FINAL PLAT
CREEKSIDE ESTATES

Re: S/D 94-75 - CREEKSIDE ESTATES ADDITION (Final Plat)

At the regular meeting of the Subdivision Committee of the Metropolitan Area Planning Commission on Thursday, January 19, 1995, the above captioned plat was considered. The action of the Committee was to recommend that this plat be approved subject to:

CASE NUMBER: S/D 94-75 CREEKSIDE ESTATES ADDITION

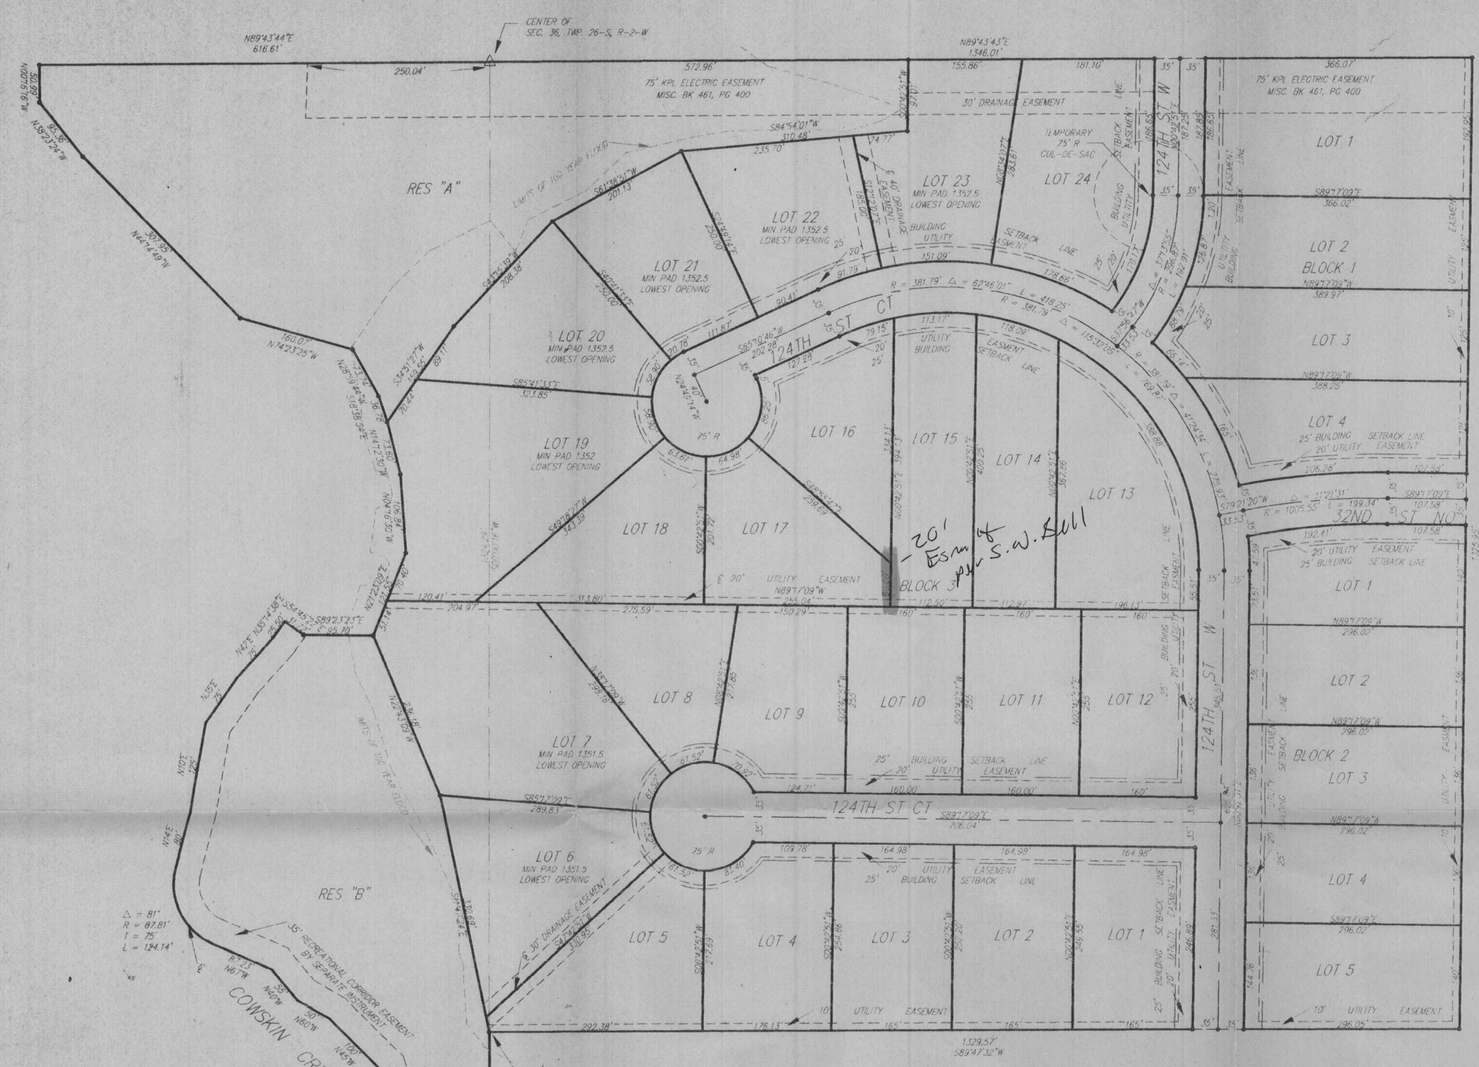
D. This area is both within 3-miles of the City of Wichita and is platting lot sizes which requires the guaranteeing of paving of the interior streets to the suburban paving standard. This guarantee shall also provide for a temporary cal-de-sac in the vicinity of lot 24, block 3.

I. Based upon the Comprehensive Plan, a recreational corridor is indicated along the Cowskin Creek located along the west line of this plat. As indicated on the plat, this corridor is being granted by separate instrument. This instrument shall be submitted to Planning for review and processing.

J. The applicant either in the plattor's text of the final plat tracing needs to cite the dedication of the temporary cul-de-sac and the conditions under which it would or will be vacated, or at least cite that it has been dedicated by separate instrument with such instrument submitted to Planning for processing with the plat.

R. The final plat shall indicate the utility easements requested by Southwestern Bell which are indicated on the enclosed "marked" copy of the plat.

S. As requested by County Engineering, certain lots shall revise the indicated minimum building pad elevations. Further, the references to "lowest opening" shall be deleted. Also, in the plattor's text, permission to carry out activities in the floodway should be placed with the appropriate Engineer rather than "governing body".
